NIC COMPONENTS CORP.

PRODUCT CHANGE NOTICE

PRODUCTS: SURFACE MOUNT FERRITE BEADS

NIC PRODUCT SERIES: NCB & NCB-H

NCB/NCB-H 0603/0805 Carrier Dimensions

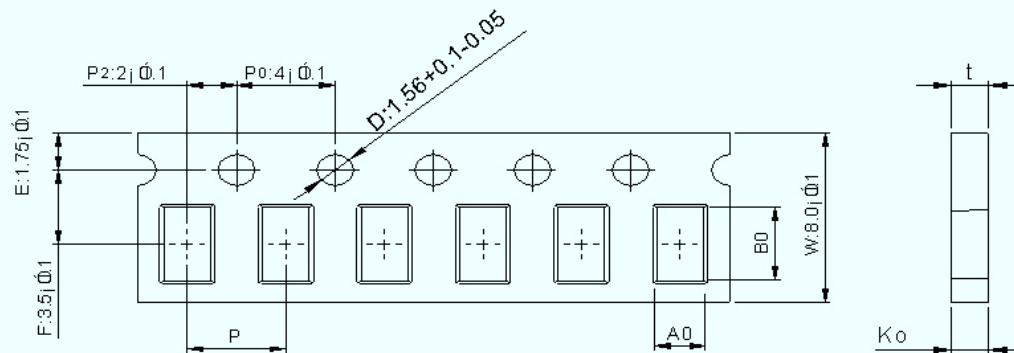
THE FOLLOWING IS NOTICE OF A CHANGE IN THE PACKAGING (CARRIER MATERIAL) FOR ALL 0603 AND 0805 PARTS.

THE CARRIER MATERIAL WILL BE CHANGED FROM EMBOSSED PLASTIC TO PRESSED PAPER.

Case Size	Bo(mm)	Ao(mm)	Ko(mm)	P(mm)	t(mm)
0603	1.85±0.05	1.05±0.05	0.95±0.05	4.0±0.10	0.95±0.05
0805	2.30±0.05	1.50±0.05	0.95±0.05	4.0±0.10	0.95±0.05
